**RE: Response to Disapproval
Area of Concern 15 – New API Separator and Area of Concern 16 – New API
Separator Overflow Tanks Investigation Work Plan
Western Refining Southwest LLC, D/B/A Marathon Gallup Refinery
EPA ID #NMD000333211
HWB-WRG-22-004**

New Mexico Environment Department (NMED) to Western Refining Southwest LLC (Western) Comment Letter “Second Disapproval, Area of Concern 15 – New API Separator and Area of Concern 16 – New API Separator Overflow Tanks Investigation Work Plan” (October 31, 2023)

Area of Concern 15 – New API Separator and Area of Concern 16 – New API Separator
Overflow Tanks Investigation Work Plan

FIGURE 3			
AOC 15 AND AOC 16 AOC 15 AND AOC 16 INVESTIGATION WORK PLAN			
WESTERN REFINING SOUTHWEST LLC D/B/A MARATHON GALLUP REFINERY GALLUP, NEW MEXICO			
Drawn By: REP	Checked By: BM	Scale: 1" = 30'	Date: 2/9/2022
File: 697-AOC-15-16

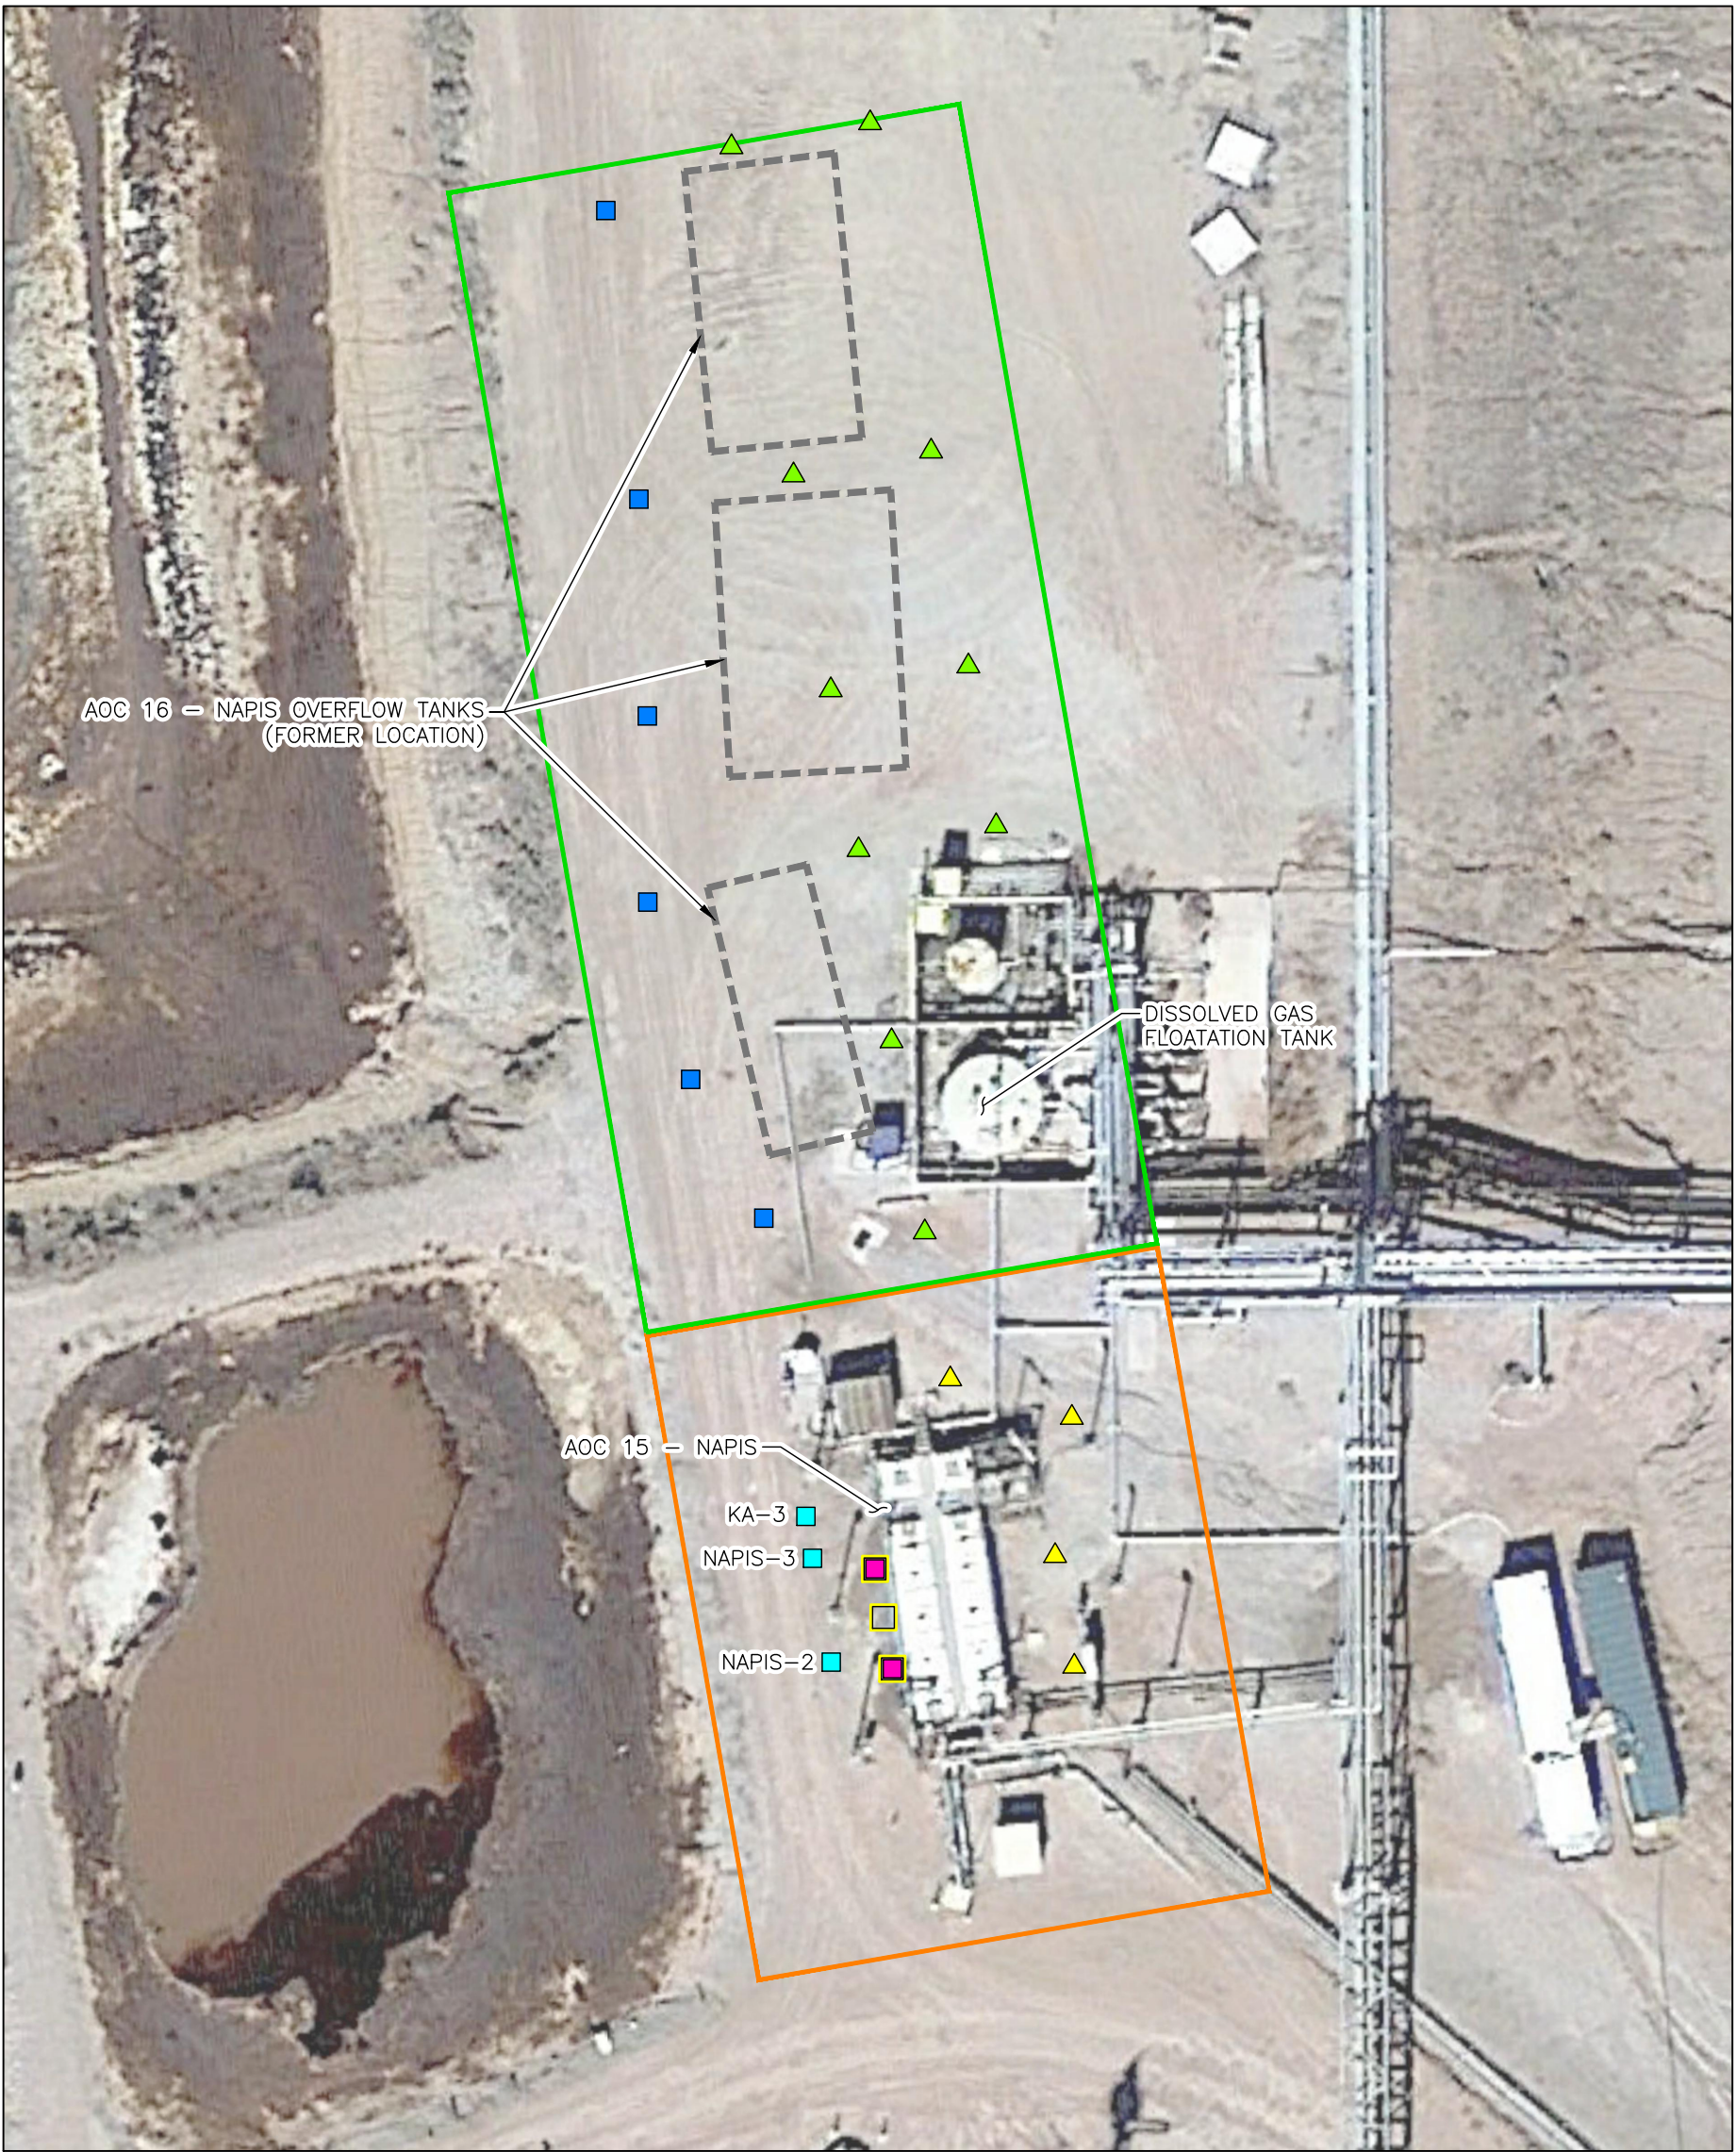
Comment 5:	Response 5:
<p>In the response to NMED’s Disapproval Comment 4, Phase 2, Step 1, the Permittee states, “[u]p to five 2-inch polyvinyl chloride (PVC) temporary bromide monitoring wells may be installed along the west wall of the NAPIS (Figure 4). These locations may be adjusted slightly to the west to maximize the potential for intercepting bromide.” Address the following:</p> <p>a) NMED’s Disapproval Comment 4 states, “if the temporary wells are located too close to the NAPIS wall, potential breakthrough may not be detected because the location of a potential leak (e.g., holes, cracks) may not be aligned with the groundwater flow path (e.g., cross-gradient from potential leak locations). Therefore, it is important that the temporary wells be sufficiently distanced from the westside of the NAPIS wall to detect potential breakthrough. The minimum distance from the temporary wells necessary from the NAPIS wall must be evaluated and discussed in the revised Work Plan.” According to Figure 4 (Proposed Bromide Monitoring Well and Sampling Locations), the proposed tracer monitoring wells are located directly adjacent to the</p>	<p>a) The Refinery is of the opinion that the location of the temporary wells are not too close to the west wall of the NAPIS, and furthermore the placement of these wells is constrained by existing infrastructure. In addition, there are three permanent monitoring wells (NAPIS-2, NAPIS-3, and KA-3) located downgradient of the NAPIS that will be monitored to detect potential breakthrough. These wells are approximately 15 feet (ft) west from the west wall of the NAPIS as shown in Figure 4.</p> <p>b) In order to ensure that there is enough coverage, a total of 8 wells will be used for sampling during the test. No modeling is proposed at this time. Figure 4 depicts the five temporary monitoring wells, three shallow vadose and two monitoring wells. Two of the three shallow vadose wells will be installed in the same boring as the groundwater well as indicated in Figure 4. These will be installed in between the NAPIS wall and the three permanent monitoring wells to the west, providing a total of eight wells to sample from. Figure 4 has been updated to include the three permanent monitoring wells. Section 4.2,</p>

NMED Comment	Western Response
<p>West Bay. It appears that NMED’s comment was not addressed in the Work Plan. Explain if the temporary wells were sufficiently distanced from the secondary containment wall or evaluate the minimum distance between the temporary wells and the NAPIS secondary containment wall necessary to detect the tracer leaked from a hole or crack that are not aligned with the direct flow path to the temporary wells. Note that dispersion of the tracer in conjunction with bulk motion of groundwater may be the only mechanism that transports the tracer cross-gradient from potential leak origins. Provide a discussion regarding the minimum distance in the revised Work Plan.</p> <p>b) According to Figure 4, two proposed tracer monitoring wells and one proposed shallow vadose monitoring well are depicted along the west wall of the NAPIS. Although the Permittee states, “[u]p to five 2-inch polyvinyl chloride (PVC) temporary bromide monitoring wells may be installed along the west wall of the NAPIS,” the Permittee did not discuss how it was determined that three monitoring wells were sufficient to capture potential tracer breakthrough at the site. The Permittee must explain how the number of wells were determined or evaluate the specific number of monitoring wells to be installed at the site based on the minimum distance from the west wall of the NAPIS, as required by Comment 5a above. It is NMED’s opinion that a simulation mode (e.g., MODFLOW/MT3D) may be useful to determine the appropriate number of wells necessary to capture potential tracer breakthrough.</p> <p>c) According to Figure 4, there are no tracer monitoring wells or shallow vadose monitoring wells proposed along the east wall of the NAPIS. Since the integrity of the east Bay must also be investigated, propose to install an appropriate number of tracer monitoring and</p>	<p>Page 15 of 18, Part 2, Step 2a has been revised to state “[S]ampling for bromide in the temporary monitoring wells located 5 ft of the west NAPIS wall, permanent monitoring wells (NAPIS-2, NAPIS-3, and KA-3) located 15 ft of the west NAPIS wall”.</p> <p>c) The Refinery is proposing to complete the bromide tracer testing solely in the West Bay. Please see response 3b above. Additionally, due to existing infrastructure, the east side of the NAPIS is inaccessible for the installation of monitoring wells. Furthermore, the east side of the NAPIS is upgradient of the groundwater flow direction, therefore monitoring for the tracer solution is unnecessary. Refer to Figure 3 of this Work Plan.</p>
